22/1145/FUL Scheme Amendments | Comprehensive redevelopment to deliver a new, mixed-use neighbourhood, comprising demolition of existing buildings and construction of four residential-led mixed-use buildings of 2 to 6 storeys, including retail, café/restaurant and flexible commercial units (Class E), residential (Class C3) and co-living (Sui Generis) accommodation, pedestrian square and public realm, amenity areas, landscaping, access, parking, servicing and associated works. | Haven Banks Water Lane Exeter Devon EX2 8BY.

Please accept this revised objection to this planning application. Our previous letter of objection is no longer relevant with some issues addressed by the developer.

Isometric showing extent of roofline changes to Block C

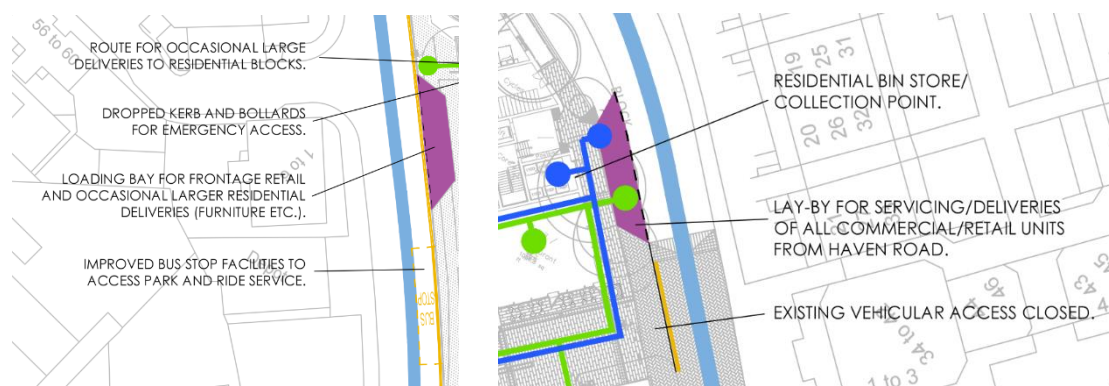
The changes to this block are a 'cosmetic' effort to counteract what is the main

problem, the 6-storey height of these parts of the building.

The revised massing at the Water Lane end of the building, contrary to other measures, makes this part of the building look more

massive than the stepped approach in the previous layout. We think that the change is contra-productive and moving away from the better solution before.

The flat roofs of buildings C and D are out of sync with the gabled roofs of the buildings around them and even with Building B. We are not convinced by the use of dark metal cladding at level 4 and partly at level 5. Some lighter coloured elements of the top floor cladding already demonstrates this (see illustration on the previous page).
